**Planning Department
Transportation Development Services**

**Re: Applebee's, 98th St.
Traffic Circulation Layout**
Engineer's/Architect's Stamp dated 2-27-15 (K09-D038)

Based upon the information provided in your submittal received 2/27/15, the above referenced plan cannot be approved for Building Permit until the following comments are addressed:

Site Plan

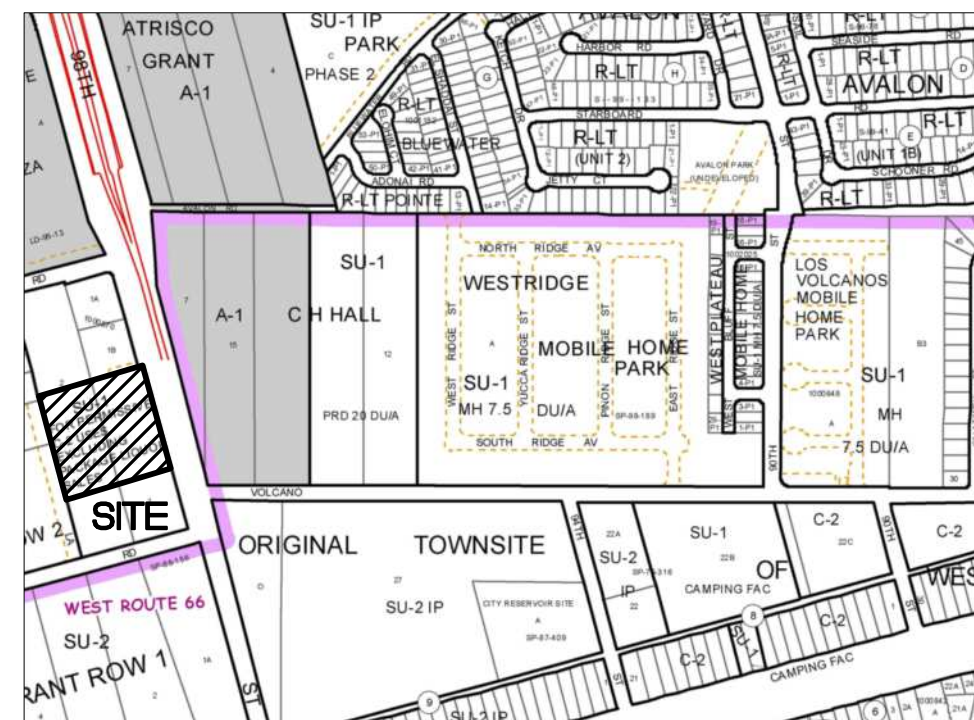
1. The proposed development looks like it may meet the threshold for a Traffic Impact Study based upon the combined square footage of the Applebee's and proposed adjacent retail site. Provide a trip generation.

2. For next submittal, please provide site address and/or legal description.
3. On next submittal, please label drawing as "Traffic Circulation Layout" in lieu of "Site Plan".

4. Provide separate D.R.C. drawings for outer curbs on 98th St. R.O.W. On the Traffic Circulation layout, provide a dimension from the median curb to the proposed curb, and label lane widths for southbound traffic on 98th Street.

5. Subject site entrance off of 98th St. must have a 5 ft. keyway for vehicles backing up out of parking spaces shown at Keyed Note 10. In order to accomplish this requirement, the developer may reduce parking space width to 8.5 ft.

6. The ADA van accessible sign must have the required language per 66-7-352.4C NMSA 1978 **"Violators Are Subject to a Fine and/or Towing."** Please show detail on drawing.

7. The ADA van accessible aisles are required to be a minimum 8.5 feet in width. Label these widths on the site plan.
8. The ADA access aisle shall have the words **"NO PARKING"** in capital letters, each of which shall be at least one foot high and at least two inches wide,

9. Parking spaces must be a minimum of 18 ft. in length. Proposed drawing shows all spaces as 16 ft. in length. Per code, "Compact Parking" shall only consist of one-third of the total number of parking spaces, excluding number of handicap parking spaces. Either increase the parking space length to 18 feet while maintaining the 24-foot wide parking aisle, or call out a 2-foot overhang over the islands to satisfy the 18-foot requirement. For all parking spaces that are kept compact, list them as "Compact".

10. Label curb radii for all curves shown; for passenger vehicles, the minimum end island radius is 15 feet, but 10 feet is shown for many of these islands. Also show the 2-foot radii as applicable. (See Figure 23.7.2 of the DPM.)

11. Per the DPM, a 6 ft. wide ADA accessible pedestrian pathway is required from the HC parking stall access aisles to the building entrances. Please show detail on drawing. Please show detail for call-out notes #5 and #25 for curb ramps, showing all details including the maximum 12:1 slope for the ramp, the maximum 2% cross-slope and all necessary dimensions. (In order to meet this requirement, a 6-foot wide landing area is required at the top of the ramps from the parking lots to the proposed retail building. Otherwise, the ramp may be changed to the same style of the ramps in front of the Applebee's as long as they are 6 feet wide.) For the Applebee's ramps, call out the ramps to be a minimum of 6 feet wide.

12. Per the DPM, a 6-foot wide ADA accessible pathway is required from the public right-of-way to the building entrances. For all note call-outs for Note 12 for the pedestrian walkways only, label the dimension of the pedestrian walkway as 6 feet. Also, provide a minimum dimension of 6 feet behind the back of the ramp on the south side of the south entrance.

13. Label the existing curb ramp on the north side of the north entrance. Call out for truncated domes to be placed on this existing ramp.
14. Design delivery vehicle route needs to be shown.

15. For each of the two driveway entrances off of 98th Street, please provide a clear sight triangle. (see the *Development Process Manual, Chapter 23, Section 3, Part D.5 Intersection Sight Distance*).

16. Please add the following note to the clear sight triangle: "Landscaping and signage will not interfere with clear sight requirements. Therefore, signs, walls, trees, and shrubbery between 3 and 8 feet tall (as measured from the gutter pan) will not be acceptable in this area." (The signage called out by Keyed Note number 18 may interfere with this requirement.)
17. Label the recording information for the existing 40-foot access easement and DRB Case Number.
18. Platting action and infrastructure list must be finalized prior to approving Traffic Circulation layout with regard to proposed curb and sidewalk.
19. Please include two copies of the traffic circulation layout at the next submittal.
